FIELD CHANGE KIT MK-846/WRA-3  
FOR  
CONTROL AND DRIVE  
OF RADIO TRANSMITTING SET AN/WRT-2 OR RADIO SET AN/URC-32  
FROM TRANSMITTER GROUP AN/WRA-3

Prepared by  
HOFFMAN ELECTRONICS CORPORATION  
Military Products Division  
El Monte, California

**PURPOSE:** This field change kit permits operation of Radio Transmitting Set AN/WRT-2 and Radio Set AN/URC-32 at an average power output of 500 watts while receiving rf drive from Transmitter Group AN/WRA-3.

25 March 1965

Figure 10. Schematic/Interconnecting Diagram for AN/URC-32

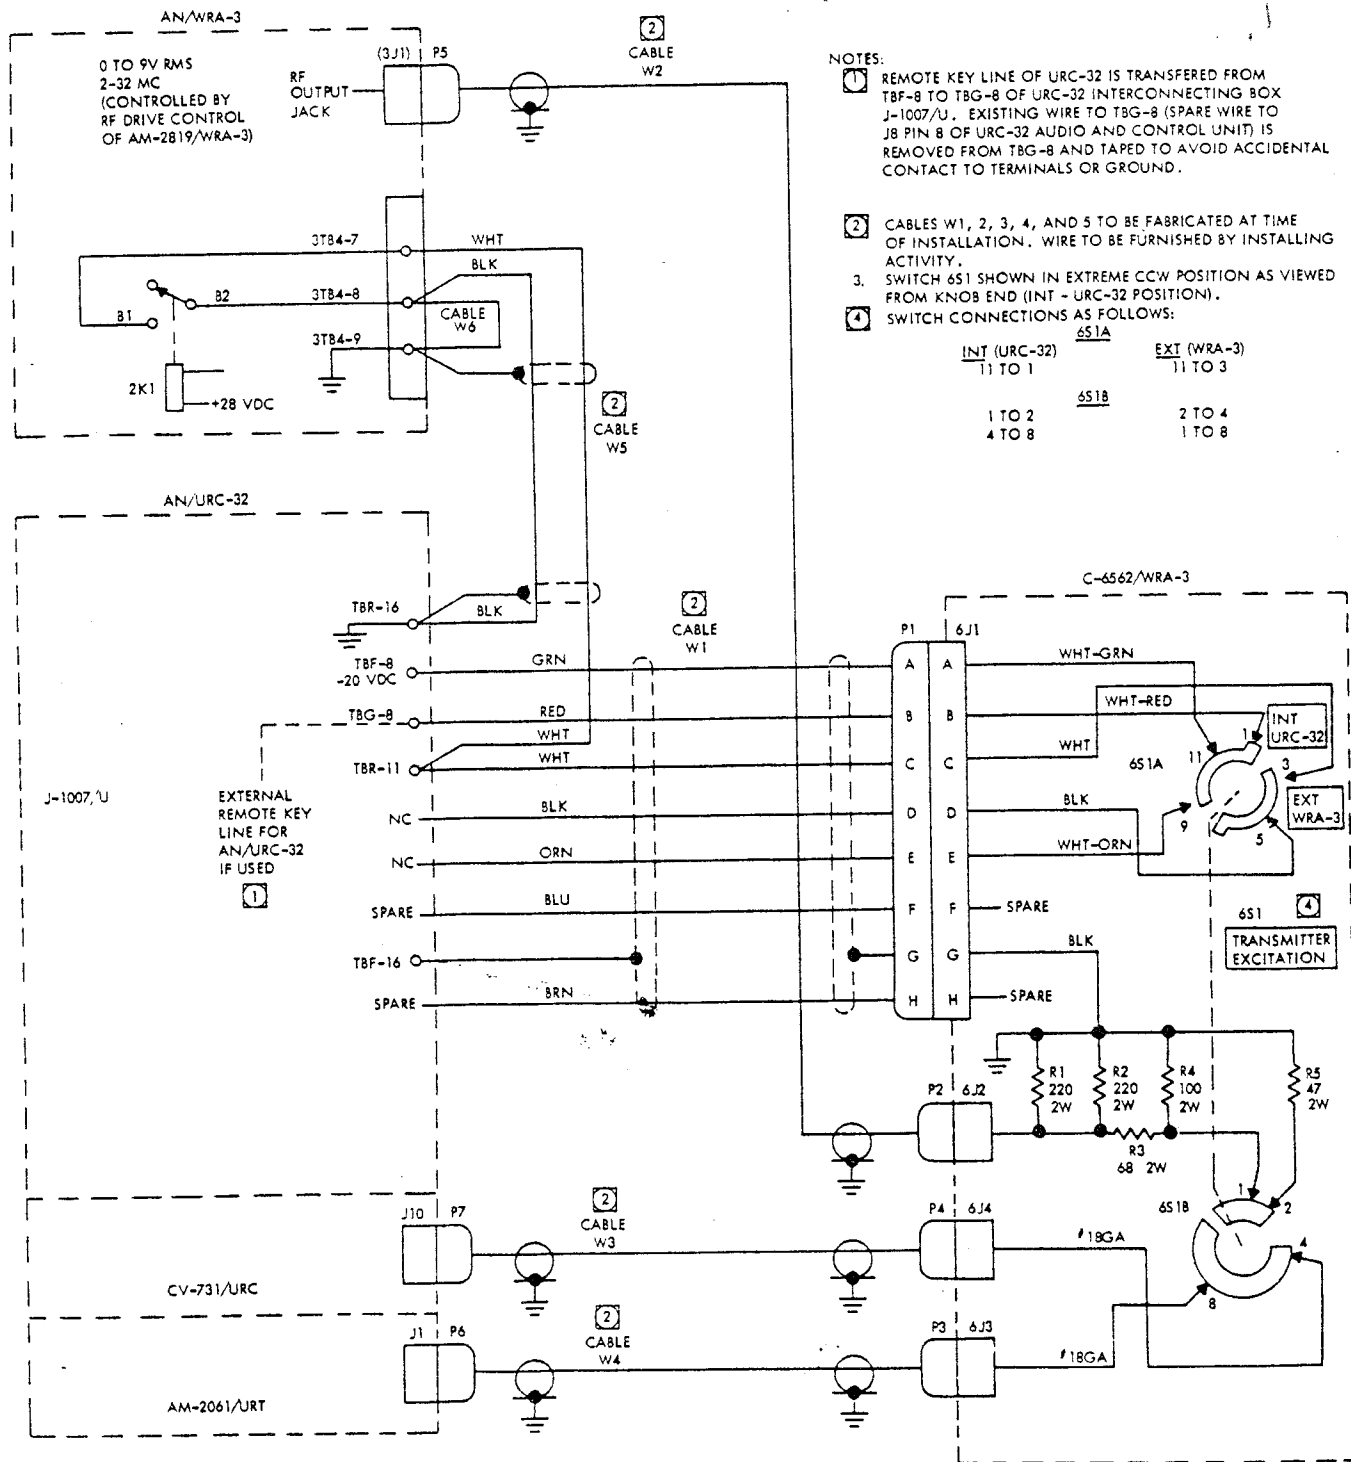
The length of this cable depends on the mounting location of the Transmitter-Transfer Control. See figure 10.

4. Fabricate coaxial cable assemblies W2, W3, and W4 by attaching a plug (Item 14) to each end of Item 35. Three of these cable assemblies are required. They will all be of different lengths depending on the location of the Transmitter-Transfer Control. See figure 10.

14. Strip the outer insulation from the free end of cable W5. Connect the white lead to TBR-11, and the black lead and the cable shielding to TBR-16 of Radio Set AN/URC-32, figure 10.

18. See figure 10. Connect one end of coaxial cable assembly W3, fabricated in step 4, to J10 of Converter-Oscillator CV-731/URC and plug the other end to 6J4 of the Transmitter-Transfer Control. Connect one end of coaxial cable assembly W4, fabricated

20. Connect one end of coaxial cable assembly W2, fabricated in step 4, to 6J2 of the Transmitter-Transfer Control and plug the other end to the rf output jack (3J1) at the lower rear of Transmitter Group AN/WRA-3. See figures 8, 9, and 10.
